# Access Compliance Report

## Public Rights-of-Way

### (Curb Ramps)

Intersection ID: 10100	Main Street: ASHLEY_RD	Cross Street: FREEDOM_DR	Location: N
ADA ID: C5B85109935E	Ramp Type: PerpDiag	Initial Pass/Fail: Fail	Overall Compliance: No
		Severity Score: 33.75

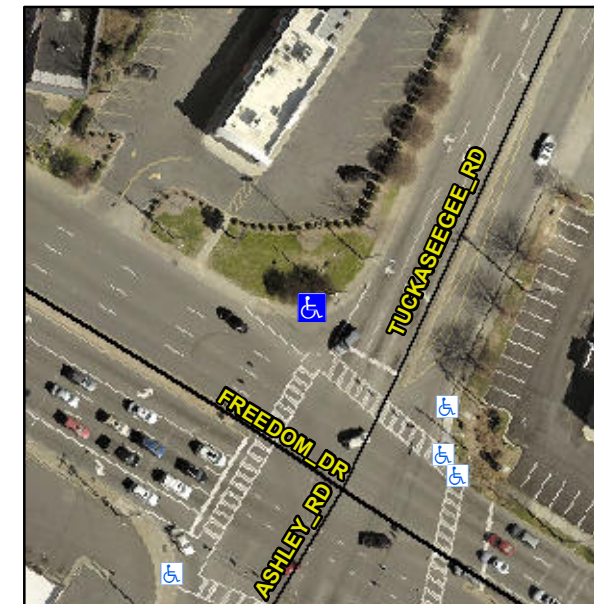
**Not Found, R304.5.1, R304.2.2, R304.5.3**

Compliance	Description	Data	Compliance	Description	Data
N/A	Ramp Length (in)	62.0	No	Ramp Slope (%)	10.2
No	Ramp Width (in)	43.5	No	Ramp XSlope (%)	5.5
N/A	Flare Type LT	N/A	N/A	Flare Type RT	N/A
N/A	Flare Slope LT (%)	N/A	N/A	Flare Slope RT (%)	N/A
N/A	Flare Traversable LT?	N/A	N/A	Flare Traversable RT?	N/A
N/A	Landing Length (in)	N/A	N/A	DWS Provided?	N/A
N/A	Landing Width (in)	N/A	N/A	DWS Contrast?	N/A
N/A	Landing Slope (%)	N/A	N/A	DWS Length (in)	N/A
N/A	Landing X Slope (%)	N/A	N/A	DWS Full Width?	N/A
N/A	Landing Curb? (Y/N)	N/A	N/A	DWS Offset (in)	N/A
N/A	Shared Landing?	N/A			
N/A	Gutter Ponding?	N/A	N/A	Gutter Slope (%)	N/A
N/A	Gutter Lip Ht (in)	N/A	N/A	Gutter X Slope (%)	N/A
N/A	Painted X Walk1?	Yes	N/A	Painted X Walk2?	Yes
	X Walk 1 Direction	To SW		X Walk 2 Direction	To SE
N/A	X Walk 1 Width (in)	111.0	N/A	X Walk 2 Width (in)	110.0
	X Walk 1 Slope (%)	2.8		X Walk 2 Slope (%)	0.5
	X Walk 1 X Slope (%)	2.7		X Walk 2 X Slope (%)	3.0

**Remove & Replace Curb Ramp With Two New Directional Ramps or Equivalent.**
